Site Observation Visit

Report # 9-Mockup Review

Project Name: Webster University- ISB
Project Location: Webster Groves
Project Number: 2014061.20
Client: Webster University
Report Prepared By: George Crow - Heitmann & Associates, Inc.
Date of Report: February 3, 2017

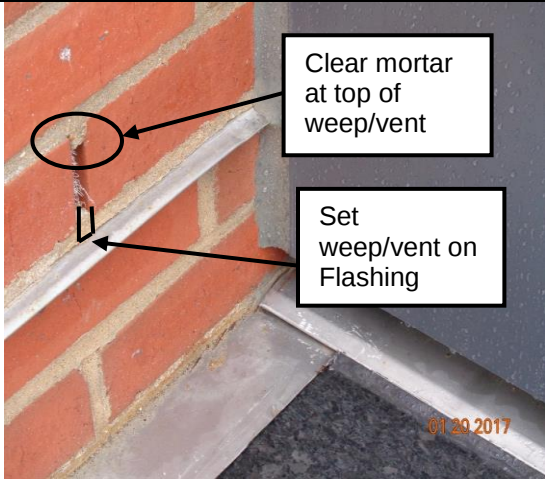
1. The weep/vent shown in **Item 9.1** was the only marginal installation of weeps identified on the mockup. The remaining weeps were installed correctly. It is important that the weeps are set on the flashing to ensure that full drainage is achieved from the brick airspace.

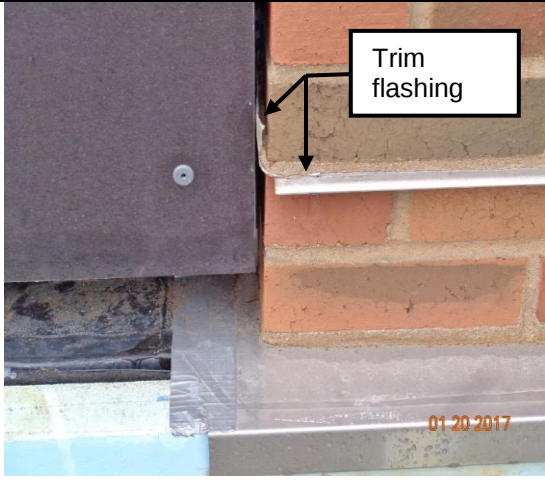
2. Although the detail shown in **Item 9.2** does not exactly occur on the building as constructed on the mockup, it is a good representation of the expected installation of flashing end dams at changes of exterior enclosure systems and door and window openings. The turned up leg of the flashing end dam should be splayed back so that it is hidden from view. The portion of the end dam at the mortar bed joint should not extend past the brick veneer face.

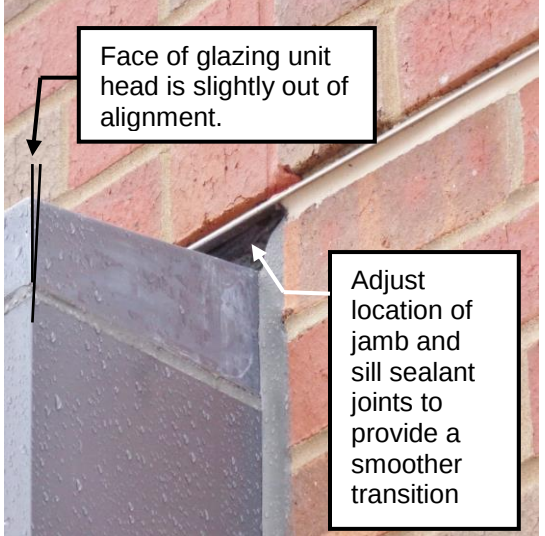
3. Projected glazing unit head as shown in **Item 9.3** was installed with a slight but visible variance from plane. It was agreed that a correction would not be implemented on the mockup but is expected to be installed correctly on the building.

Additionally, the transition at the jamb and head perimeter sealant joints at the upper corner is not smooth. The jamb and sill sealant joints may need to be slightly recessed from the brick face to facilitate better alignment at the head sealant joint.
